Project:	2023-RFP-057 West 40 Subdivision Development Project		
Addendum No.	2	No. of Pages:	4
Date:	July 20, 2023	Doc. No:	P7201-2066075788-10(1.0)

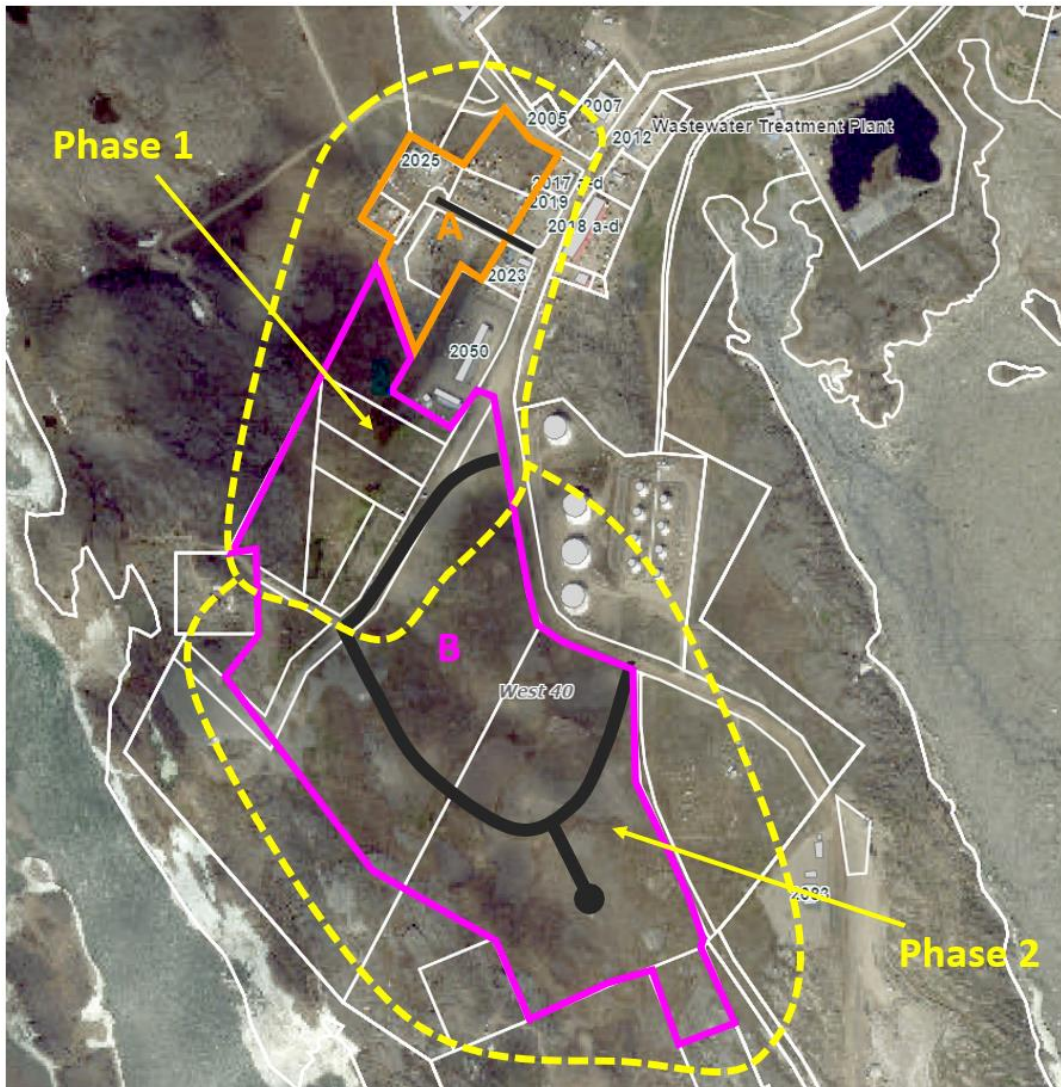
The spatial scope of 6.1 and 6.2 remain unchanged. The spatial scope of 6.3, 6.4, and 6.5 has been reduced to Phase 1 as shown in the photo below. At a high level, 6.3, 6.4, and 6.5 includes:

- Improvements to Iqaluit Lane (cul-de-sac in Area A)
- Improvements to and realignment of Hubbard Lane
- Drainage improvements to the existing leased lots in Area A
- Development (select cutting and grading to provide level sites with adequate access and drainage, refer to A1) of the undeveloped lots (current or revised layout based on development of Plans) in Area B that fall within the area of Phase 1 on both sides of Hubbard Lane
